Drawing revised by HGP in areas to indicate proposed amendments

Date	Feb 2021
Drawn By/Checked By	RW/VC
Scale	1:200@A1
Revision	**P4**
Project	**Kingston Wharf Brighton**
Title	**Proposed Ground Floor (Podium Level)-Level 00 (Sheet 1)**
Dwg #	**20086-HGP-PL-302**
Status	**PLANNING**

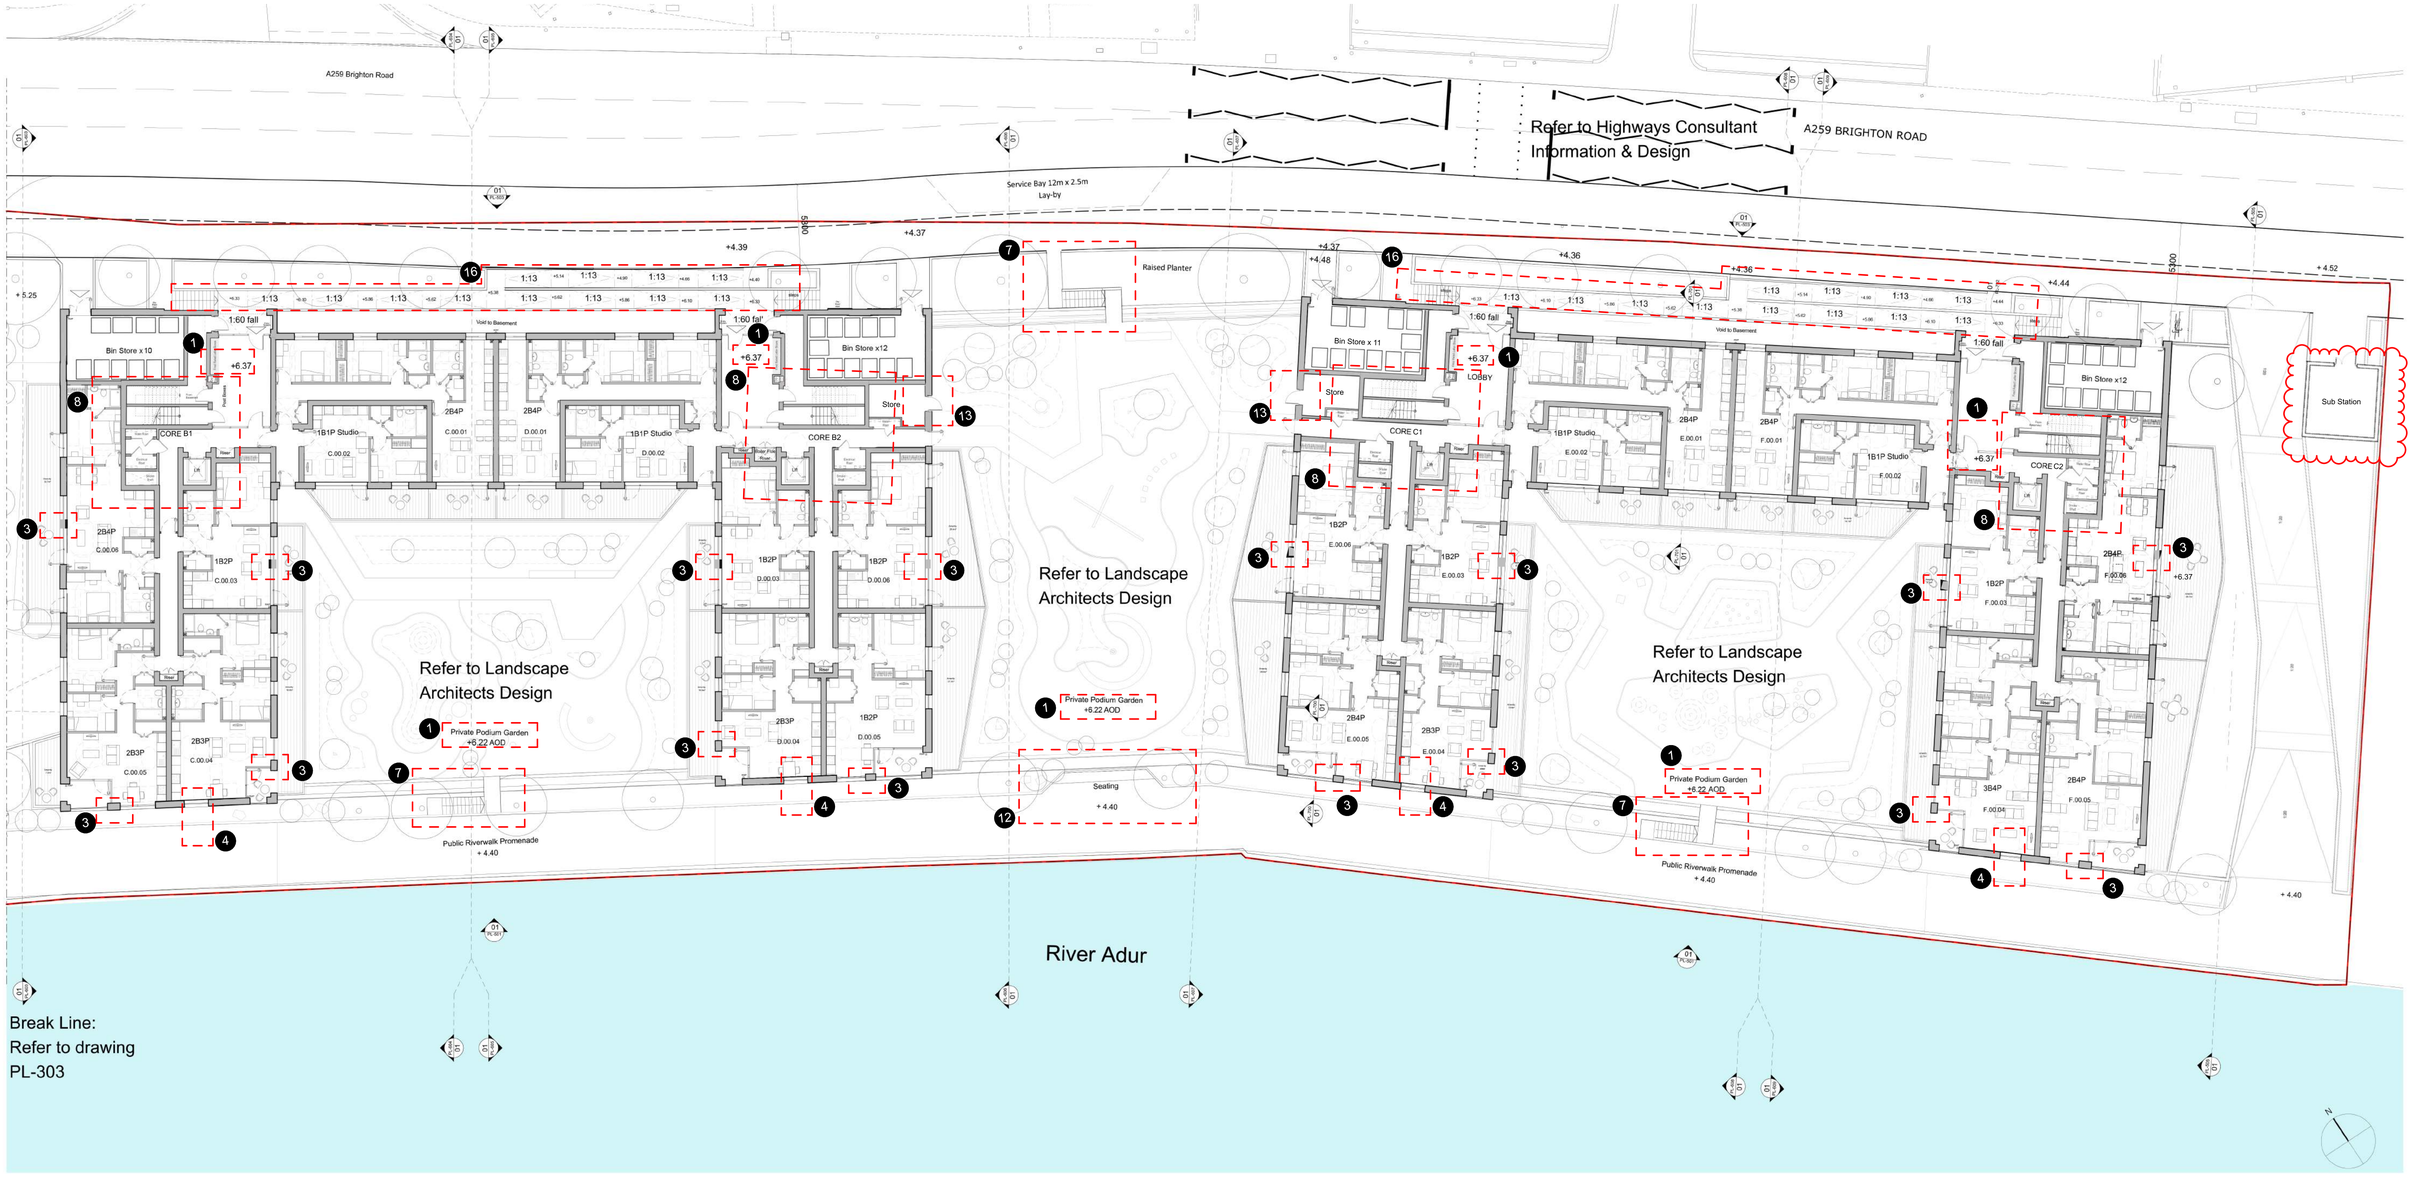
1 Levels amended to suit reduction in building height.

2 Building height reduced and basement raised out of tidal zone to mitigate the risk of flooding.

3 Brick piers introduced to provide secure junction to window & baustrade fixing.

4 Window positions revised to suit structural requirements.

5 Windows replaced with tax windows to meet fire strategy compliance.

6 Ventilation grilles removed to avoid sea water exposure to basement.

7 External stair as additional means of escape added to meet fire strategy compliance.

8 Cores revised to meet fire strategy compliance.

9 Sprinkler tank added to meet fire strategy compliance.

10 Parking layout amended to suit basement changes.

11 Wall alignment amended to facilitate basement structure and sea wall requirements.

12 Seating alcove adjusted to suit structural requirements and to provide additional space for sprinkler plant room in the basement.

13 Plant and store room doors to open externally to meet fire strategy compliance.

14 Substation size amended to meet servicing strategy.

15 Glass door replaced with solid door to meet fire strategy compliance.

16 Ramp extended to suit change in levels and artwork added to soften street scene
